Service Bulletin

Subject: Information on Missing A/C Refrigerant Charge Label on Replacement Front Compartment Front Sight Shield

Models: 2013-2014 XTS
Equipped with RPO LFX or LF3
Vehicles Built Prior to September 16, 2013

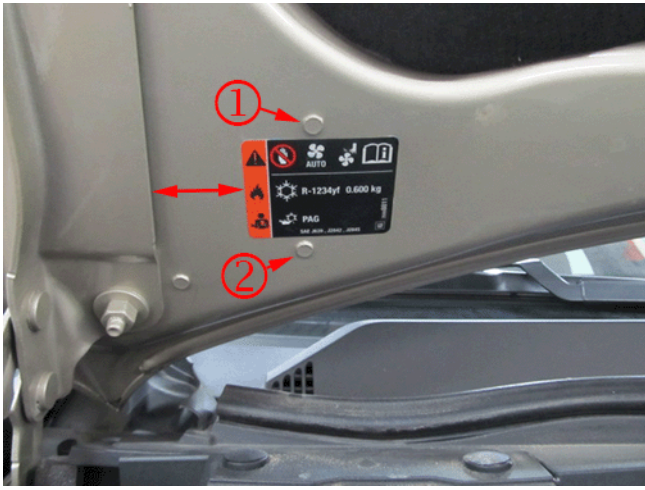
Some technicians may notice during replacement of the front compartment front sight shield that there is no A/C Refrigerant Charge label affixed to the replacement part.

1. Old Label

2. New Label

This is due to the new service part not including the A/C Refrigerant Charge Label as shown above.

The new A/C Refrigerant Charge label will be installed on the right inner side of the hood of the vehicle.

Install the label 1½ inches (38 mm) parallel to the right hood hinge in between the two rivets like shown above.
